Title of Change:	Additional Mold Compound Supplier and Leadframe Dimension Change for D2PAK Case Outline 418AJ from onsemi Suzhou, China
Proposed First Ship date:	11 Sep 2024 or earlier if approved by customer
Contact Information:	Contact your local onsemi Sales Office or Sunny.Hou@onsemi.com
PCN Samples Contact:	Contact your local onsemi Sales Office. Sample requests are to be submitted no later than 30 days from the date of first notification, Initial PCN or Final PCN, for this change. Samples delivery timing will be subject to request date, sample quantity and special customer packing/label requirements.
Additional Reliability Data:	Contact your local onsemi Sales Office or Jutta.Xu@onsemi.com
Type of Notification:	This is a Final Product/Process Change Notification (FPCN) sent to customers. FPCNs are issued 90 days prior to implementation of the change. onsemi will consider this change accepted, unless an inquiry is made in writing within 30 days of delivery of this notice. To do so, contact PCN.Support@onsemi.com

Document #:FPCN25822X

Issue Date:04 Jun 2024

D²PAK-3 (TO-263, 3-LEAD) CASE 418AJ ISSUE F

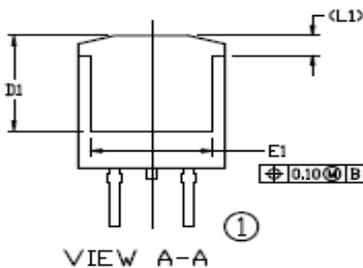
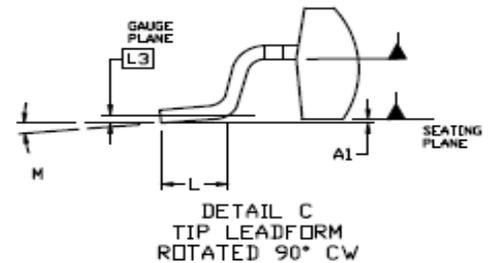
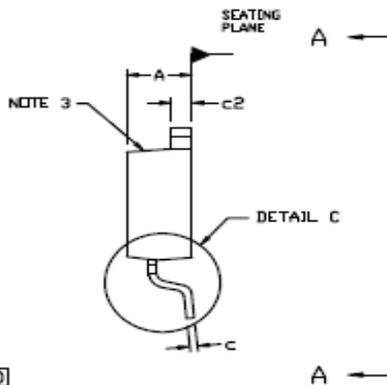
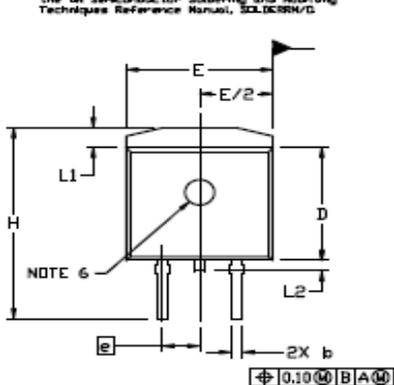
This FPCN is to inform customers that onsemi is qualifying new green mold compound GR710F from China local supplier Hysol, as alternative source on selected D2PAK Discrete products in onsemi Suzhou, China. This will help improve supply chain flexibility.
In addition, onsemi is consolidating D2PAK leadframe. Leadframe dimension changes are shown in the table below. The MOD remains CASE 418AJ however there is a change in the location of mold feature.

Before Change Description	After Change Description
Lead Frame	Reference the table showing the before and after dimensions that is below.	Reference the table showing the before and after dimensions that is below.
Mold Compound	KCC KTMC5900GM F01.	Hysol GR710F & KCC KTMC5900GM F01.
Appearance	Mold feature optional locates at centre, appearance detail reference below picture.	Mold feature optional locates at corner, appearance detail reference below picture.

From	To
Appearance change	Optional mold feature located in center 	Optional mold feature located in bottom left

DIM	DESCRIPTION	MOD (Same)			Current LF (mm)			Proposed LF (mm)			Remarks
		CASE 418AJ (mm)			MIN	NOM	MAX	MIN	NOM	MAX	
		MIN	NOM	MAX							
b	Lead width	0.51	----	0.99	0.775	0.800	0.825	0.788	0.813	0.838	Both in MOD spec.
c	Lead thickness	0.30	----	0.74	0.480	0.500	0.520	0.371	0.381	0.391	Both in MOD spec.
c2	Heat sink thickness	1.14	----	1.65	1.27	1.30	1.33	1.17	1.27	1.28	Both in MOD spec.
D1	Heat sink length	6.60	----	----	7.850	----	----	8.705	8.730	8.755	Both in MOD spec.
E	Package width	9.65	----	10.67	9.850	9.880	9.910	10.135	10.160	10.185	Both in MOD spec.
E1	Heat sink width	6.22	----	----	7.350	----	----	8.220	----	----	Both in MOD spec.
e	Lead pitch	----	2.54	BSC	2.510	2.540	2.570	2.515	2.540	2.565	Both in MOD spec.
